BMW Motorrad USA

Service Information Bulletin

Subject: Ignition remains on when ignition switch is turned off

Models: R nineT (K21)

Wiring-harness variants

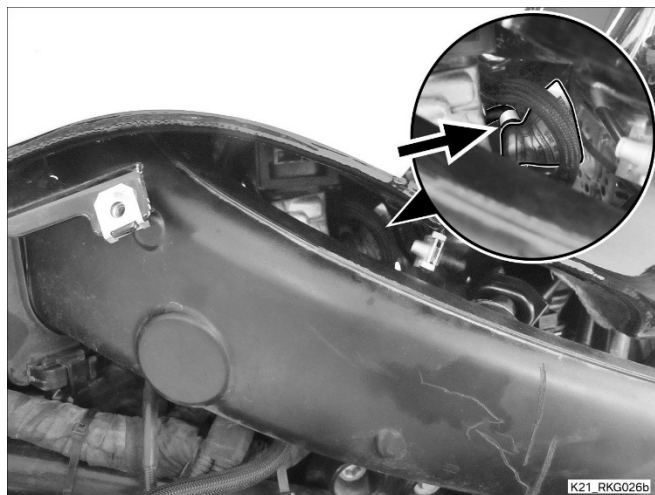
INFO / INFO **01**: standard wiring harness (part number 61 11 8 548 701) **up to** November 04, 2014

INFO **02**: standard wiring harness (part number 61 11 8 548 701) **from** November 05, 2014 onward

INFO **03**: **From** March 30, 2015 **until** April 01, 2015, the "INFO 01" version of the wiring harness (part number 61 11 8 548 701) was installed together with a retrofitted load-shedding relay (part number 61 12 8 553 659).

The grey label with the part number is attached to the vehicle wiring harness near the diagnostic connector. Check the "INFO" number to identify the variant.

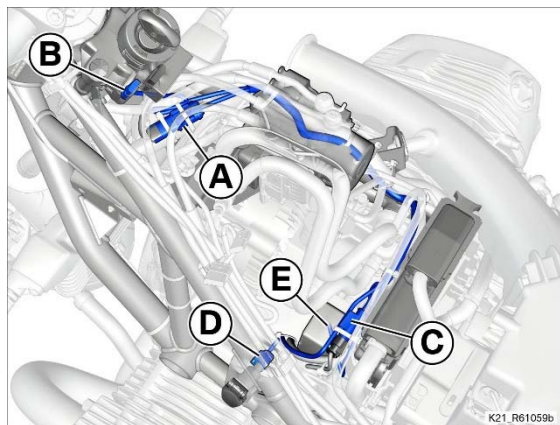
Note: Ascertaining whether the load-shedding relay with additional wiring harness has already been retrofitted is a matter of removing the right side cover and visually checking at the right side of the vehicle.

If the grey label of the additional wiring harness and the white mark are visible at the point indicated (arrow), the vehicle is already fitted with the additional wiring harness with load-shedding relay.
